Peach Bottom – Timing and Criteria for RCS Failure

Sensitivity Calculations for Peer Review

Surry – Uncertainties in Hydrogen Combustion in the Mitigated STSBO

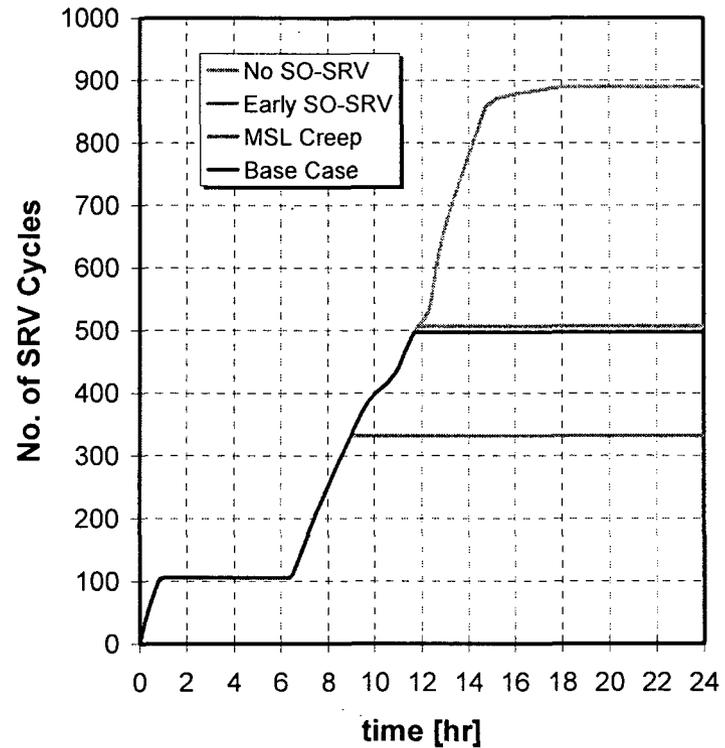
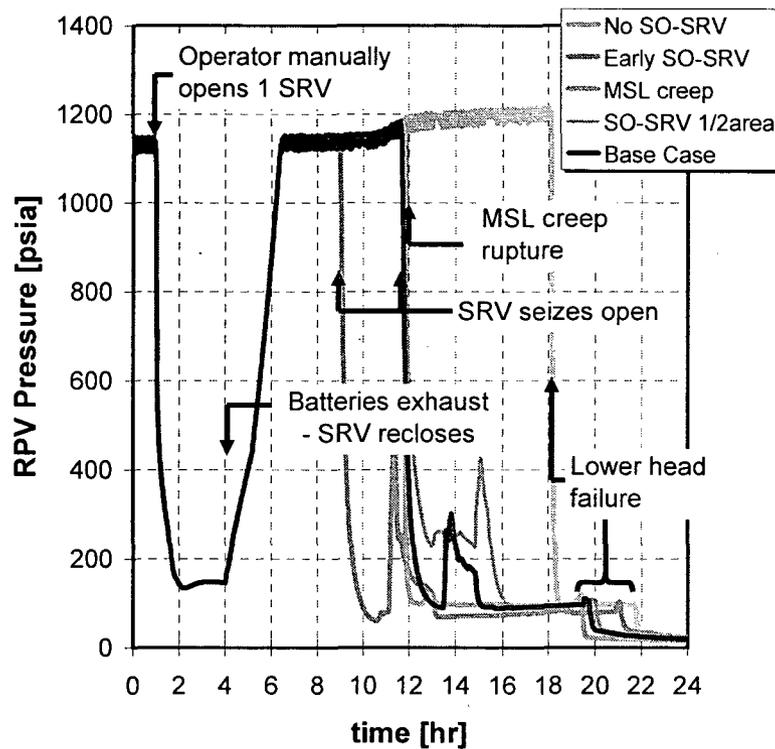
- Multiple natural mechanisms for early RCS failure are represented in the Peach Bottom MELCOR model
 - Stochastic failure of a cycling SRV to re-close
 - Thermal seizure of an SRV in the open position
 - Steam line or nozzle creep rupture
- SOARCA baseline calculations – SRV thermal failure was the ‘lead’ or first mechanism to occur
- Peer reviewers seemed to generally agree with our approach, but questioned the sensitivity of the results to this modeling

- Thermal seizure in half-open position.
 - Work continues to explain long-term Cs release for this case
- Earlier (stochastic) failure to reclose (level @ TAF)
 - Failure at ~70% confidence level
- No SRV failure to reclose, main steam line (MSL) creep rupture
 - Represents lower likelihood case
- No depressurization (ignores predicted SRV seizure or creep rupture)
 - Not judged a credible case, but examined in response to peer review request

- **Additional information provided by peer reviewer at 3rd peer review meeting suggests that a purely stochastic SRV failure may be less likely**
 - However, early SRV failure may be more likely due to combination of large number of lifts and modest heating above design
- **Examination of material properties suggests SRV thermal failure modeling approach (fails after 10 lifts after reaching 1000K) is not best estimate**
 - Valve may be weaker thermally than currently modeled
 - Examination of valve material properties indicates dramatic decrease in spring constant with temperature well below 1000K
 - Considering side calculations (ABACUS) using MELCOR thermal hydraulic predictions to develop more realistic estimate of time of SRV thermal failure, and feed that back into MELCOR
